HOPE CREEK GENERATING STATION  
DOCKET NO. 50-354  
FSAR COMMITMENT STATUS THROUGH AUGUST 1984

ATTACHMENT I  
HOPE CREEK GENERATING STATION  
FSAR COMMITMENT STATUS THROUGH AUGUST 1984

QUESTION 220.21 (SECTION 3.7.2)

FIGURE 220.21-19  
 RESPONSE SPECTRA COMPARISON,  
 AUXILIARY BUILDING AT ELEV. 54' -0",  
 N-S, SSE, 2% DAMPING

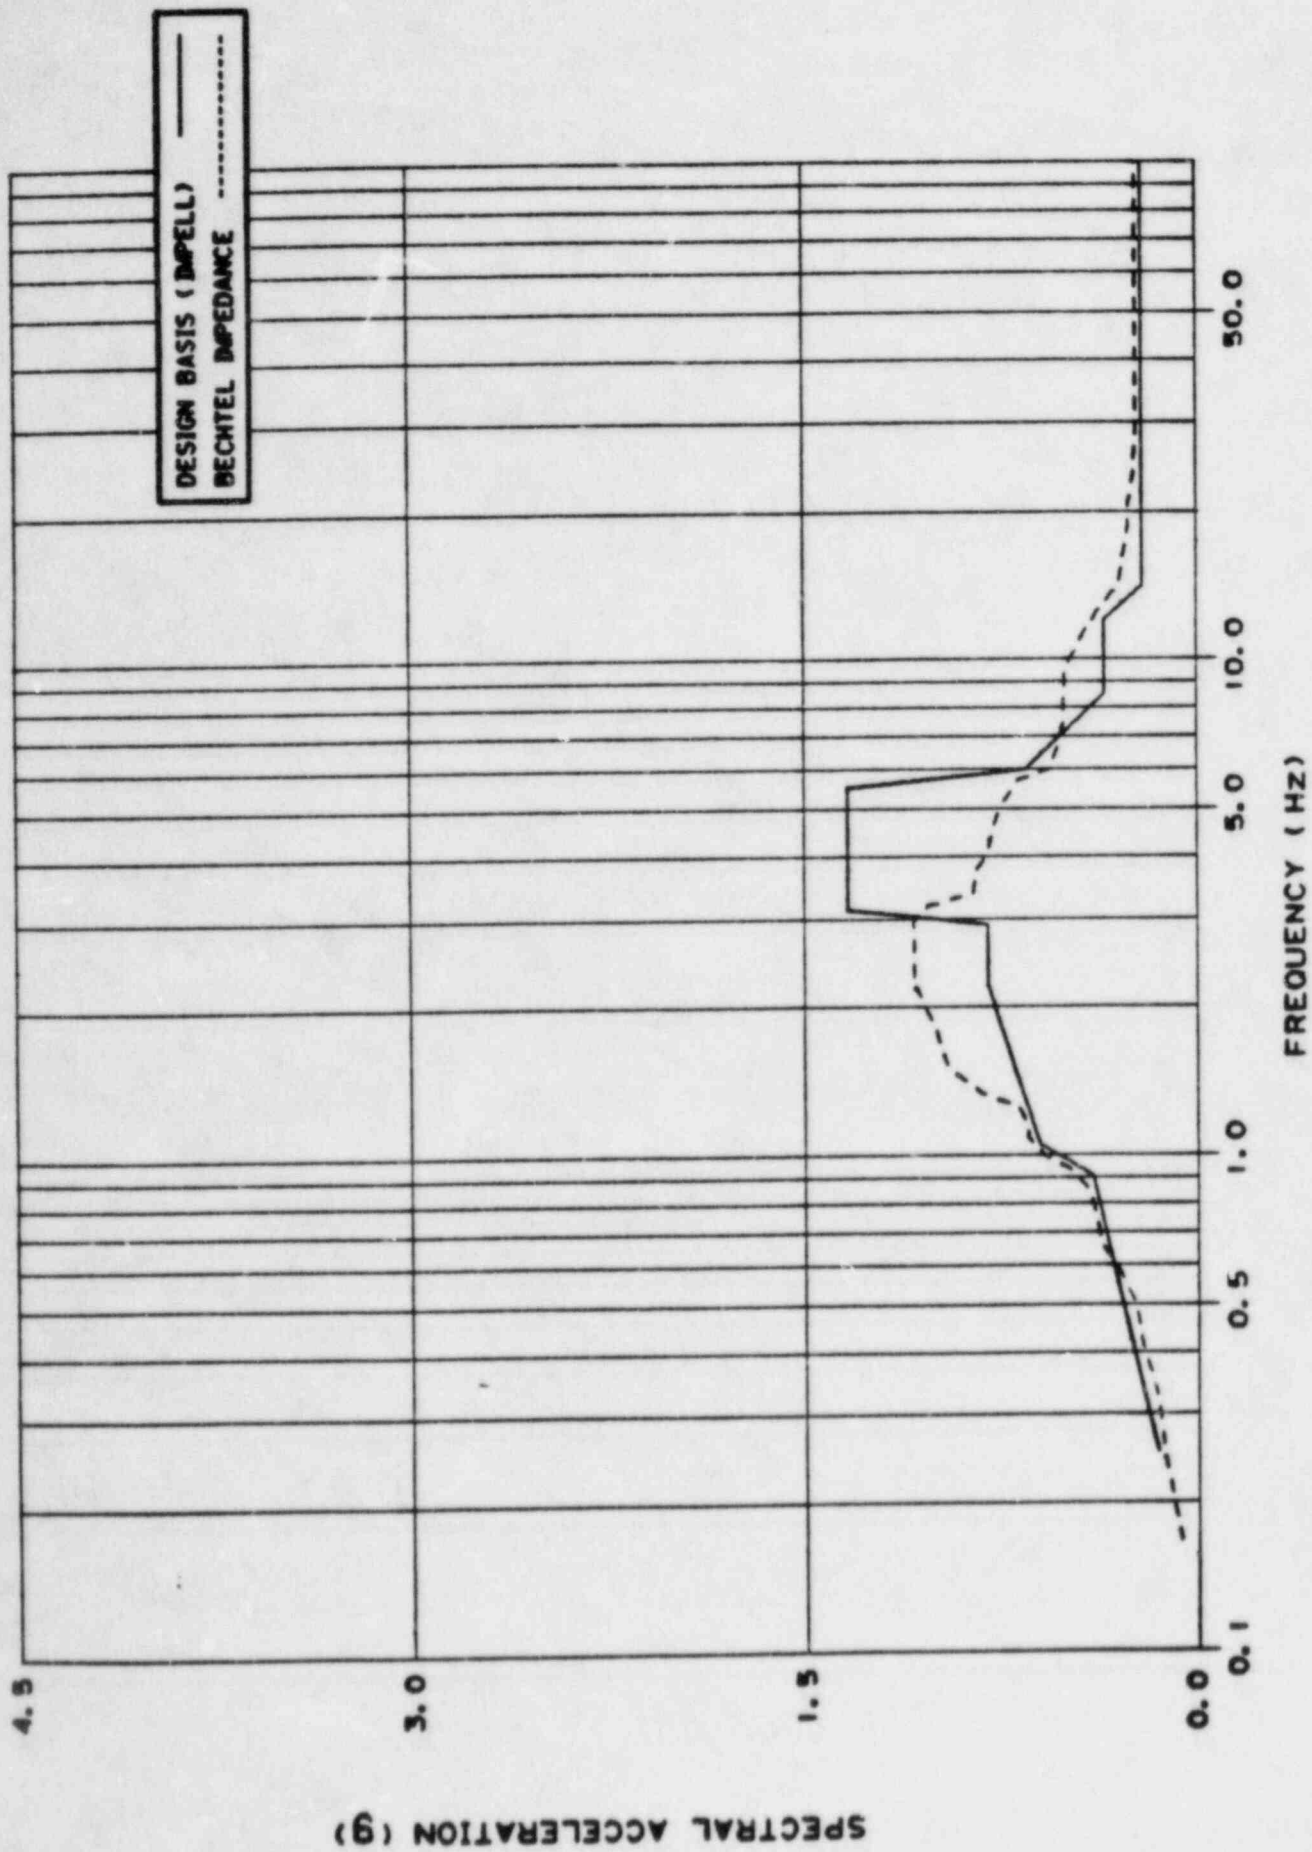
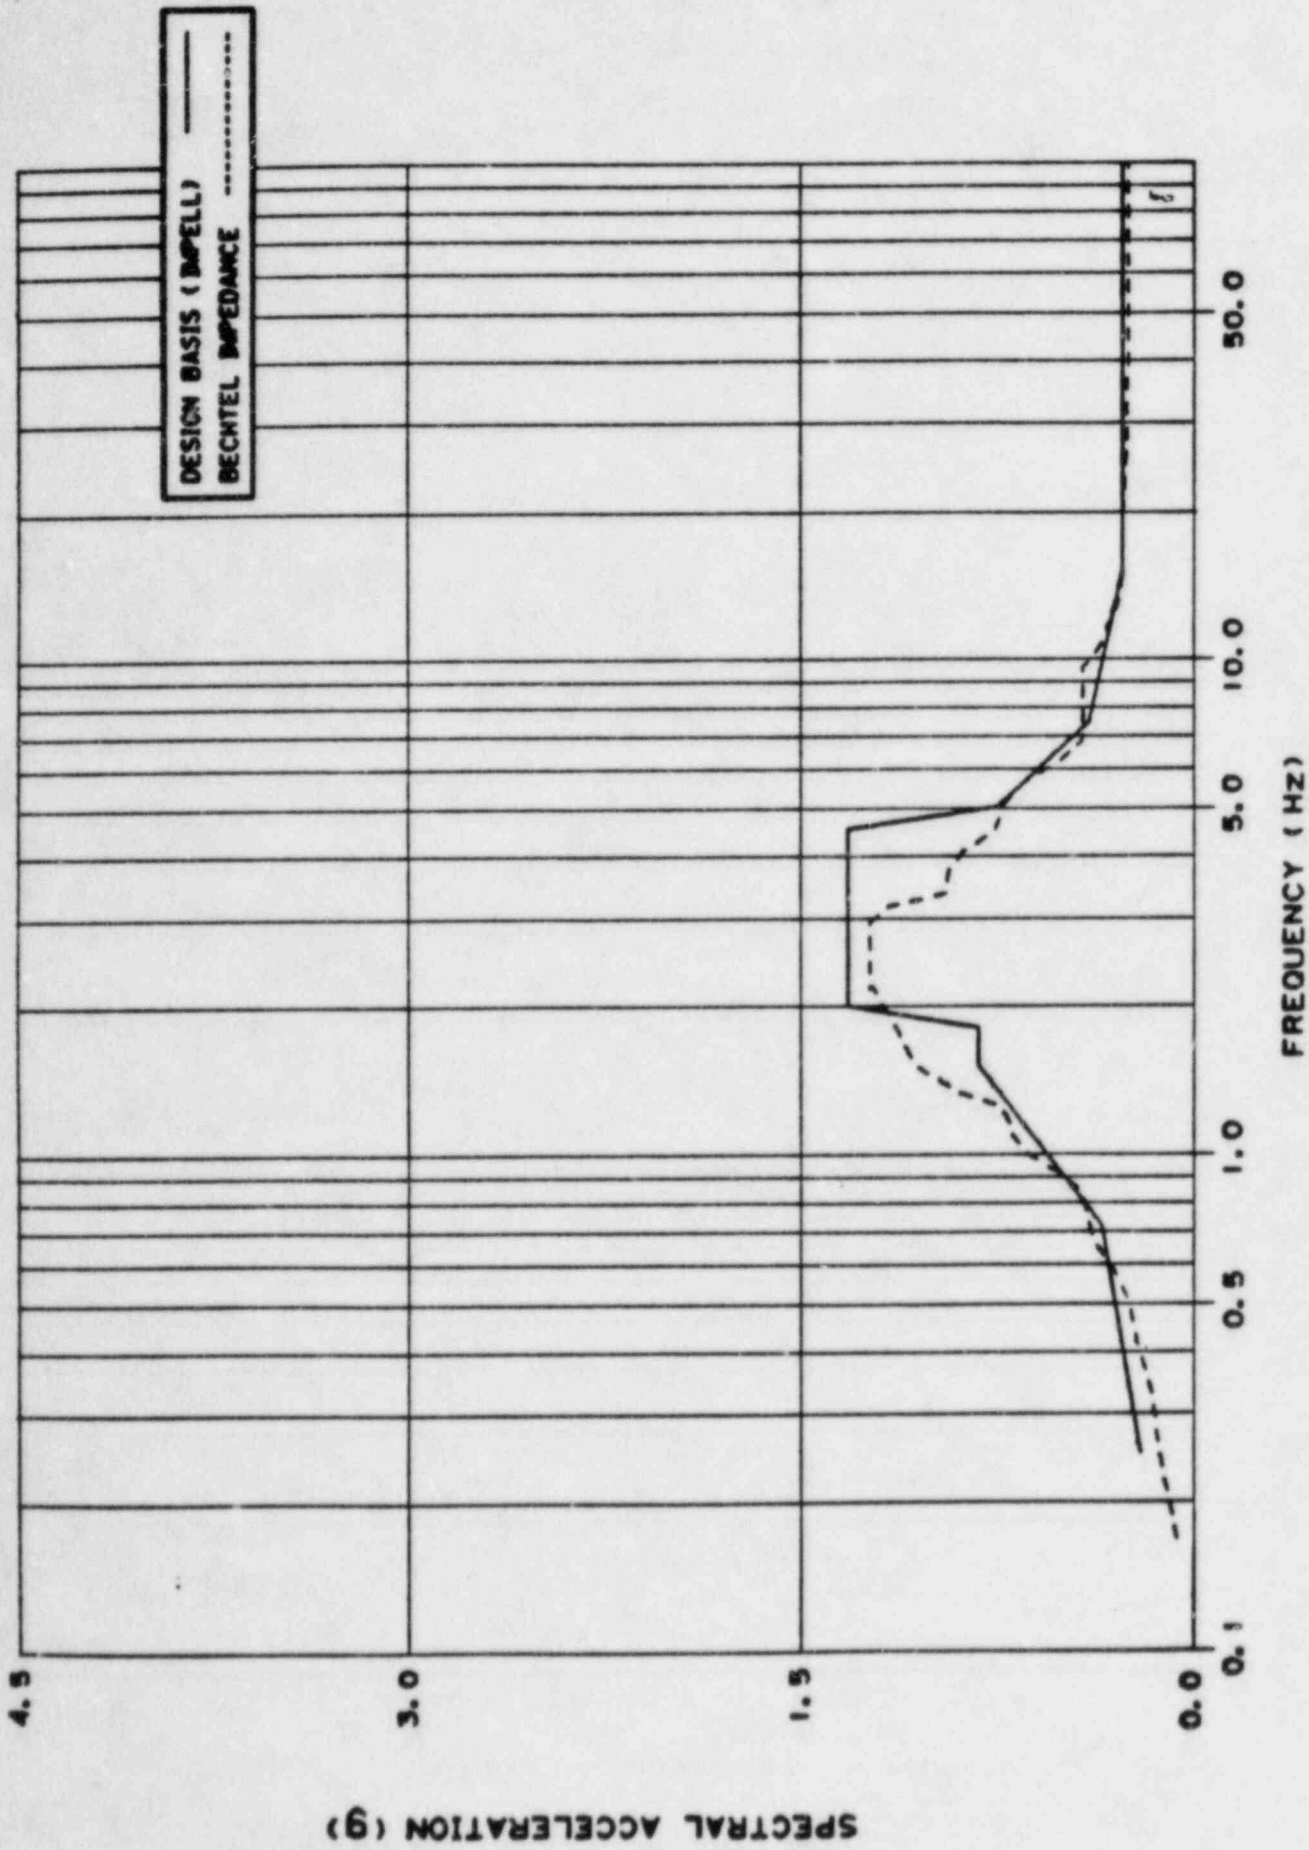
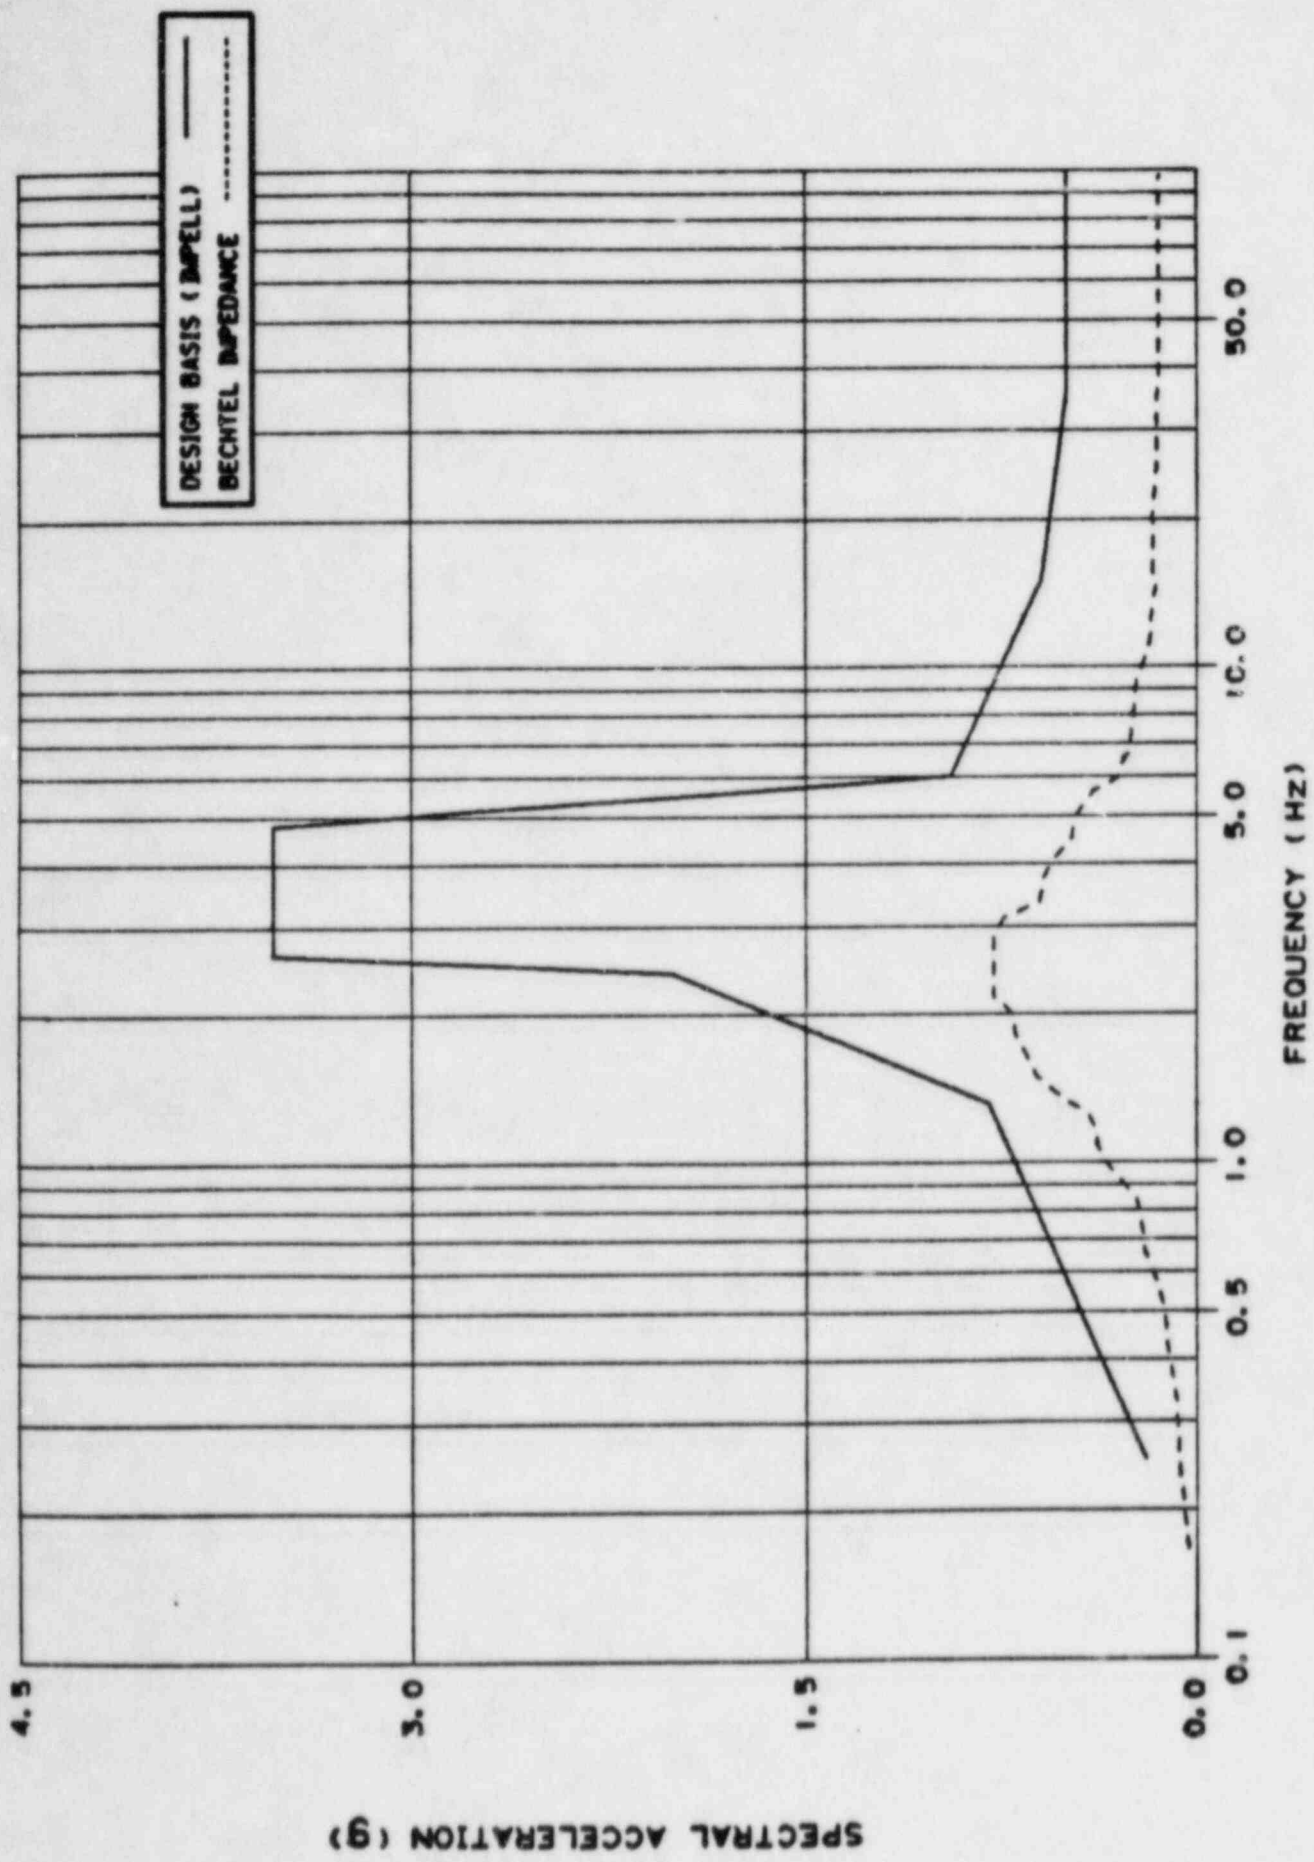
The Hope Creek soil-structure interaction analysis is performed by applying a specified earthquake input motion at the base of the finite-element model. The base level input motion is generated through a deconvolution analysis. The applicable SRP criteria for soil-structure interaction analysis require that both the half-space and finite-element approaches should be considered. (For details refer to SRP 3.7.2-11.4). Public Service should perform necessary analyses to demonstrate conformance to the criteria.

Figures 220.21-1 through 220.21-54 show a comparison of the 2 percent damping response spectra obtained from the design basis finite element and the impedance analyses for the reactor building, auxiliary building and the service water intake structure (SWIS).

¶ For the reactor and auxiliary buildings, the peak spectral accelerations obtained from the impedance analysis are generally lower than those obtained from the design basis analysis. However, the impedance analysis response spectra are not completely enveloped by those obtained from the design basis analysis, especially in the frequency range from 1.0 to 3.5 Hz. Also, there are some local exceedances in the higher frequency range, as shown in Figures 220.21-1 through 220.21-36. ¶ For the SWIS (Figures 220.21-37 through 220.21-54), the impedance analysis response spectra are generally enveloped by those obtained from the design basis analysis at elevation 114.0 feet. For other elevations, the impedance analysis spectral accelerations exceed the design basis spectral accelerations in some frequency ranges. These ranges vary approximately between 1.5 and 10.0 Hz.

forces and moments obtained from the impedance analysis exceeded the design basis values at various locations within these buildings. The auxiliary building seismic shear forces and moments obtained from the impedance analysis are less than the design basis shears and moments.

Since the impedance analysis results are not completely enveloped by the design basis finite element analysis results, sampling studies are conducted to confirm the adequacy of the plant design. These sampling studies include an evaluation of the following items:

In all cases, the items reviewed during these sampling studies can accommodate the loads resulting from the impedance analysis. Therefore, the impedance analysis results have no impact on the plant design.
